Subject: Application for modification to Neuse Buffer Certificate for the NC 55 widening to a multi-lane facility from SR 1108 (Wake Chapel Road) to SR 1114 (Ralph Stevens Road) in Wake County. TIP No. R-2907, State Project No. 8.1403501, Federal Aid Project No. STP-55(5). WBS Element 3.4515.3.2. NCDOT Division 5.

The purpose of this submittal is to modify the Neuse Buffer Certification. The modification of the certification is for the hydraulic design at Site 3. The revised design does not compromise NCDOT's compliance with the existing permit conditions. This modification application contains revised roadway construction plan sheets 17 and 18.

Summary of Changes

PROJECT REFERENCE NO. R-2907	SHEET NO. 11
R/W SHEET NO.	
ROADWAY DESIGN ENGINEER JOHN C. LANGFORD	HYDRAULICS ENGINEER RALPH STEPHENS
PROFESSIONAL SEAL 15825 JOHN C. LANGFORD	PROFESSIONAL SEAL 18180 RALPH STEPHENS

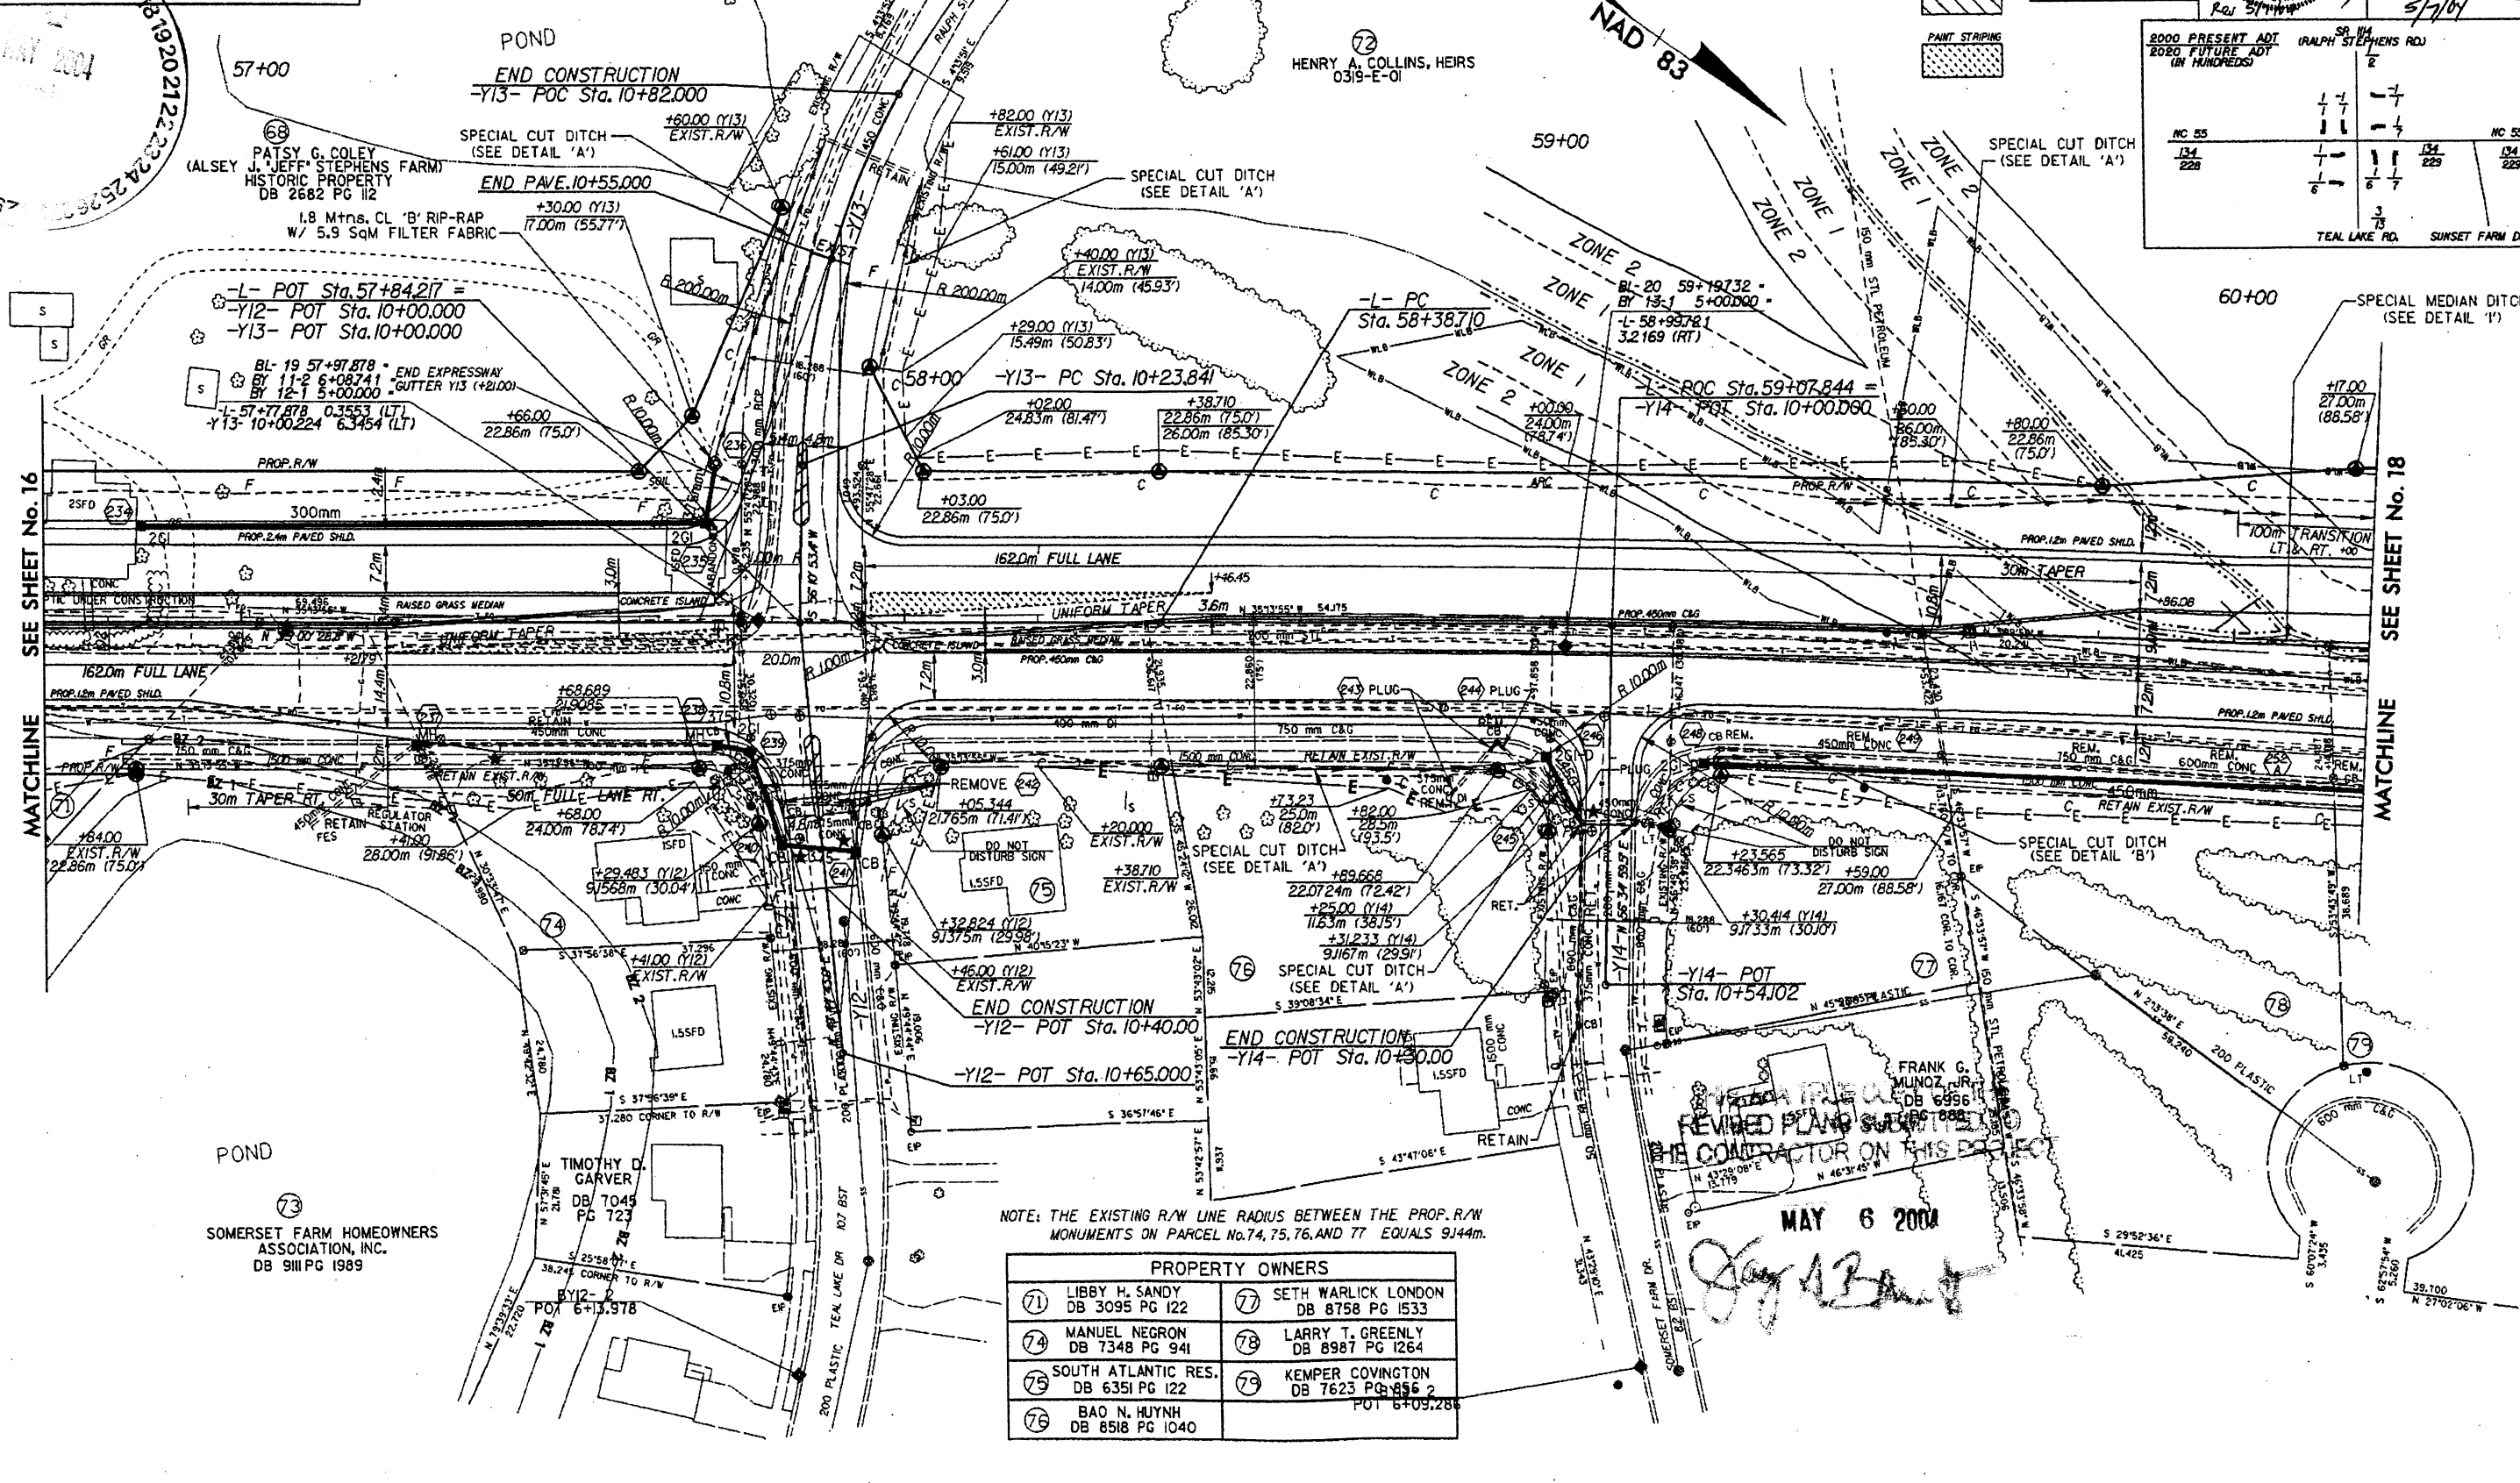
1. Site 3: Catch basins, 300 mm pipe structure and 375 mm pipe structure from Station 59+60 to 60+00 Left (see Permit Drawing 8 of 14 dated 11/29/01 and 9 of 14 dated 11/29/01)

2. Site 3: Catch basin and 375 mm pipe structure at Station 58+96 Right (see Permit Drawing 8 of 14 dated 11/29/01)

The NCDOT roadway design unit has recently revised the roadway due to a utility line conflict. Due to conflicts with an existing gas line, the super elevation for the left turn lane has been modified to drain away from the median. With this change in the super elevation, catch basins, a 300 mm pipe structure and a 375 mm pipe structure from Station 59+60 to 60+00 Left, and a catch basin and a 375 mm pipe structure at Station 58+96 Right have been eliminated from the roadway design. This change eliminates a point source discharge and provides sheet flow to the roadside ditch. Stormwater flows to the same point in the landscape through sheet flow instead of a point discharge. The hydraulics unit has indicated that the hydraulic design of the project remains in compliance with the riparian buffer rule. There are no additional impacts to riparian buffers from this revision.

DELETED STRUCTURE NOS. 247, 250, 251 AND 252
CHANGED SUPERELEVATION FROM 0.02 TO NC

PROJECT REFERENCE NO.	SHEET NO.
	R-2907	18
R/W SHEET NO.		
ROADWAY DESIGN ENGINEER	HYDRAULICS ENGINEER	
CONST. REV.		
R/W REV.

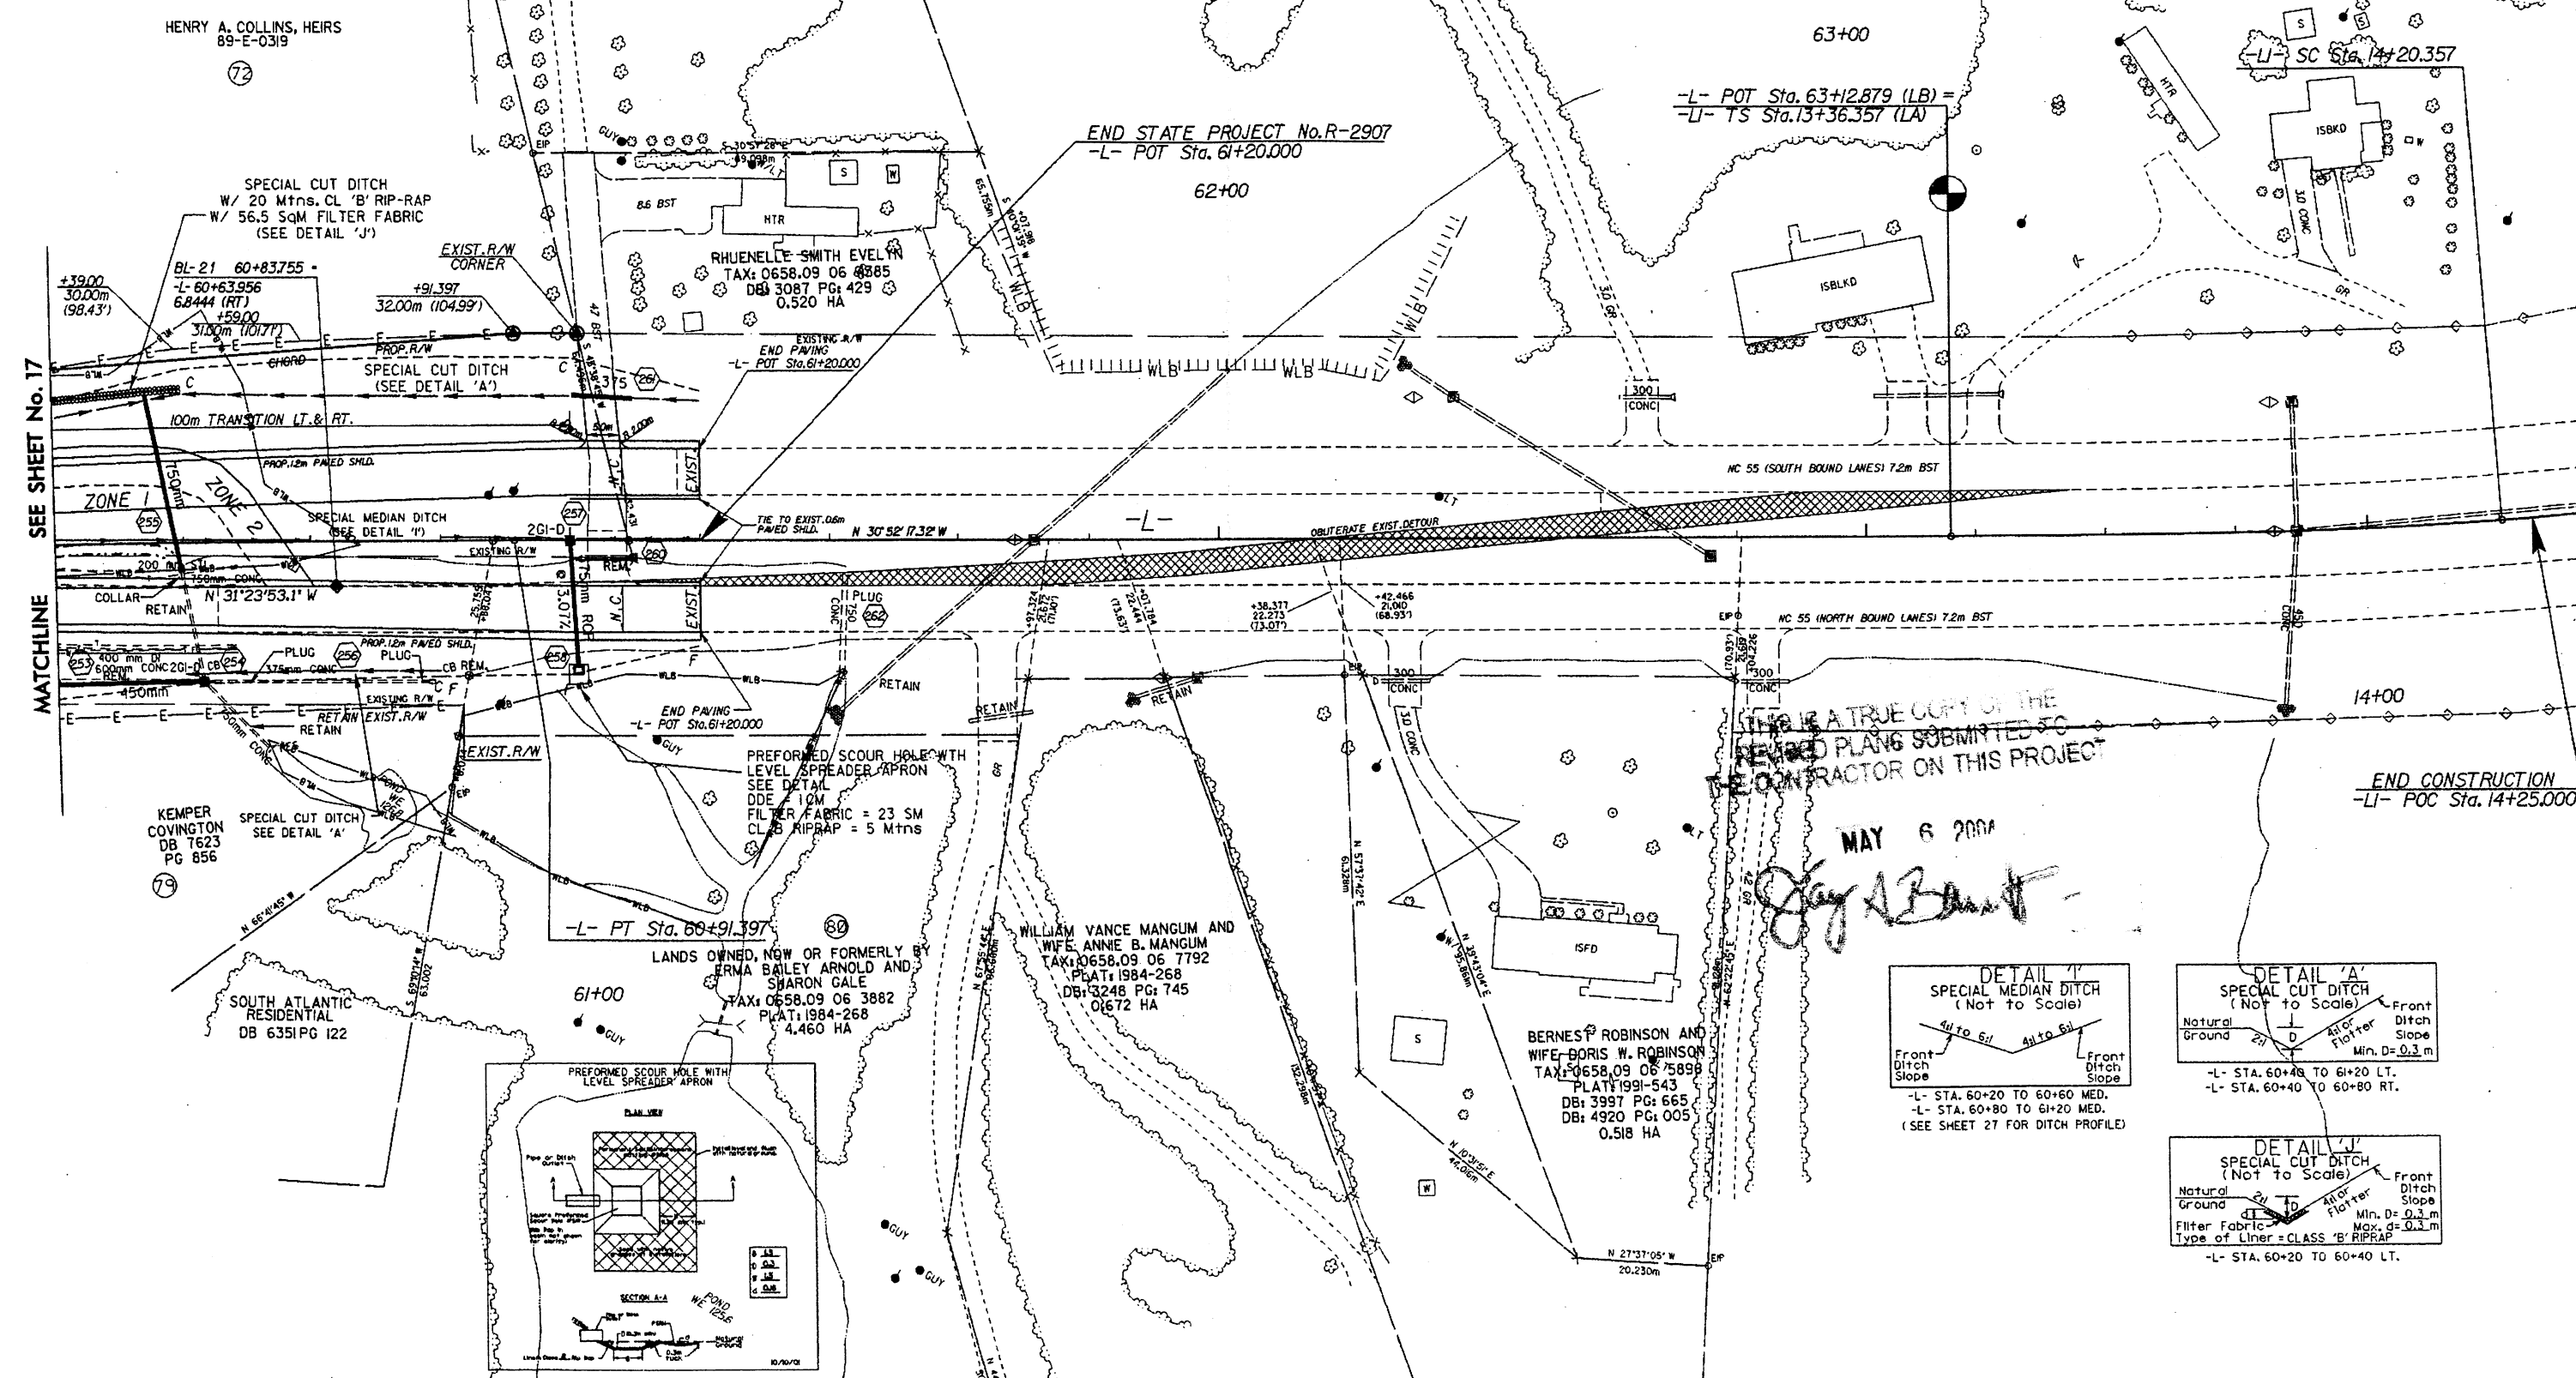
3. Site 3: 900 mm pipe structure at Station 60+40 L (see Permit Drawing 9 of 14 dated 11/29/01)

The permit drawing and original plan sheet indicates the existing structure is a 900 mm pipe structure that would have been extended with a 900 mm structure as part of this roadway project. The stakeout of the structure during construction has indicated that the existing structure actually is a 750 mm pipe structure. Therefore, the hydraulic design has been revised to extend the existing structure with a 750 mm pipe structure. The hydraulics unit has indicated that the existing 750 mm structure is sufficient to convey water. There are no additional impacts to the stream from this revision.

CHANGED SUPERELEVATION FROM 0.02 TO NC
CHANGED EXISTING 900mm RCP TO 750mm CONC.
CHANGED PROPOSED 900mm RCP TO 750mm RCP
AT STRUCTURE NO.255
